Issues-1

Issues-2

Figure 33-30

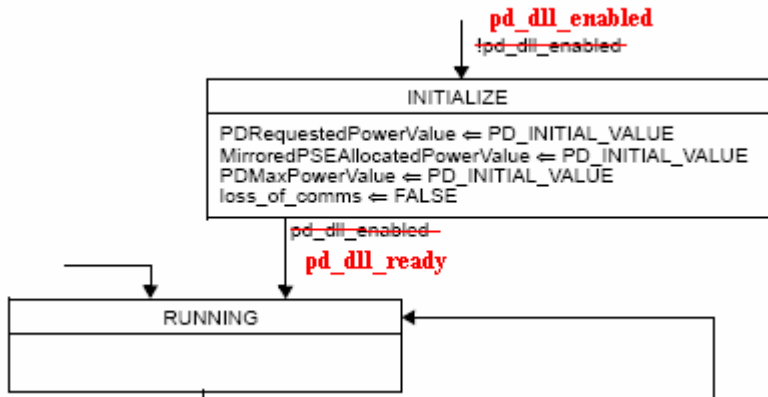
PDs should be given sufficient time for boot-up. There is no indication from the PD that the boot-up is complete and DLL engine is up and running.

Section 30.9.2

Define a new MIB variable in oPD managed object class under DLL PD Power Classification Basic Package

aPDDLLReady

Section 33.6.6.2

Define state variable:

pd_dll_ready

This variable is updated by the PD system software. This variable maps into the aPDDLLReady attribute (reference as above)

Figure 33-29

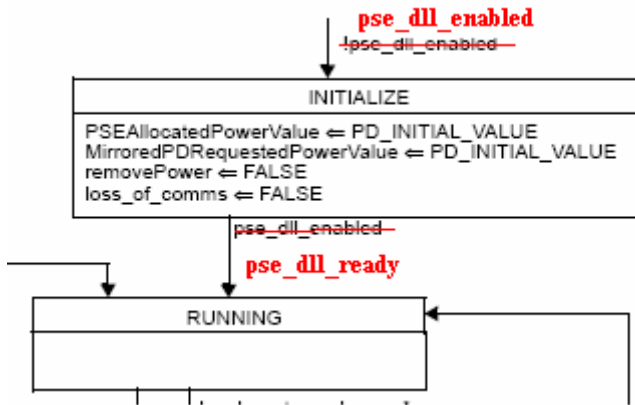
Type-1 PSEs should be given sufficient time for boot-up. We need to use the 10 second timer only for type-2 PSE for the purpose of mutual identification. There needs to be an indication from the PSE that the boot-up is complete and DLL engine is up and running.

Section 30.9.1

Define a new MIB variable in oPSE managed object class under DLL PSE Power Classification Basic Package

aPSEDLLReady

Section 33.6.6.2

Define state variable:

pse_dll_ready

This variable is updated by the PSE system software. This variable maps into the aPSEDLLReady attribute (reference as above)
